**NEPAL ELECTRICITY AUTHORITY**  
PROJECT MANAGEMENT DIRECTORATE  
**POWER TRANSMISSION AND DISTRIBUTION SYSTEM STRENGTHENING PROJECT (PTDSSP)**  
**POKHARA-BHARATPUR DISTRIBUTION SYSTEM REINFORCEMENT PROJECT**

PMD/PTDSSP/PBDSRP-077/78-01: Design, Supply, Installation and Commissioning of Underground Distribution Network under Pokhara and Bharatpur Distribution Center including Reinforcement and Automation.

BIDDER'S CLARIFICATION NO.-1		
S.No.	Reference to Tender Clause

Existing Communication Network From Pokhara/Bharatpur to Load Dispatch Center (LDC)

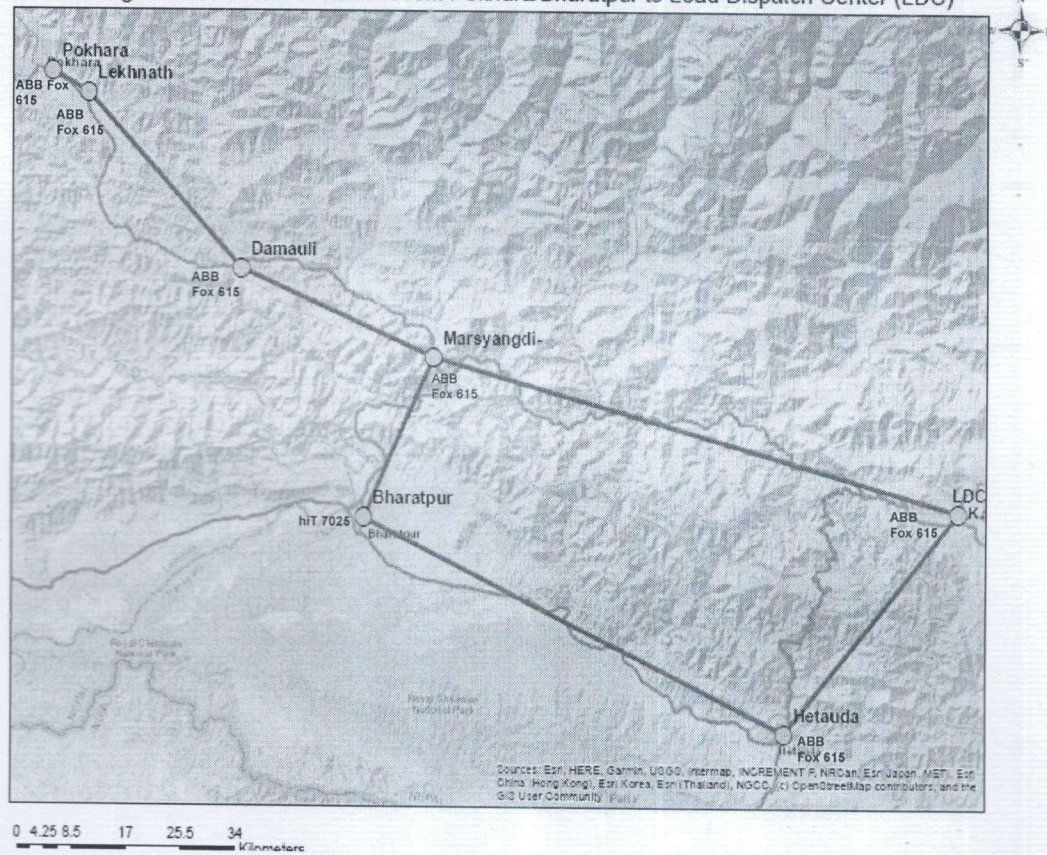
15	General	General	In case of discrepancies between Technical specification, drawings and Bid Price schedule, Bid price schedule shall be considered as final. Please confirm	Confirmed
16	General	Architecture	Please provide Typical Architecture indicating the Integration of New Sub systems with existing Communication System based on SDH network of the Customer.	It will be finalized during detail engineering
17	Section 6.3 - Specification of Equipment and Construction Material Section 1-2 - Clause 2.1	The equipment supplied shall support existing network for Power system operational requirements	Please provide communication architecture drawing of existing network.	Existing communication architecture from Pokhara and Bharapour Substation to LDC, Kalmahandu is attached in Appendix-II.
18	Section 6.3 - Specification of Equipment and Construction Material Section 1-2 : Network Configuration and Equipment Characteristics - Clause 2.2.3.1	The Contractor shall synchronize the existing equipment and all the new equipment under the contract using existing Master clock, if available. The Contractor shall provide the additional clocks as required under the set of clocks indicated in BPS. In addition to GPS input reference, the synchronization clock must have provision to take INPUT reference coming from another clock.	For the referred clause, we do not envisage supply of additional clocks since the same is not covered in BPS. Also referring to the Specification Clause, we understands that the GPS Master Clock (NTP Server) with GPS Antenna is existing in the Distribution Control Centre (DCC). Accordingly, Bidder assumes that the additional Clocks mentioned in the Specification is Digital Slave Clocks which shall sync with the GPS Master Clock based upon receipt of the Pulse input. Bidder also wants to understand whether, Layer-2 Network Switch indicated as part of the SDH Equipment shall sync with the GPS Master Clock	No such clause is not mentioned in the bid document.
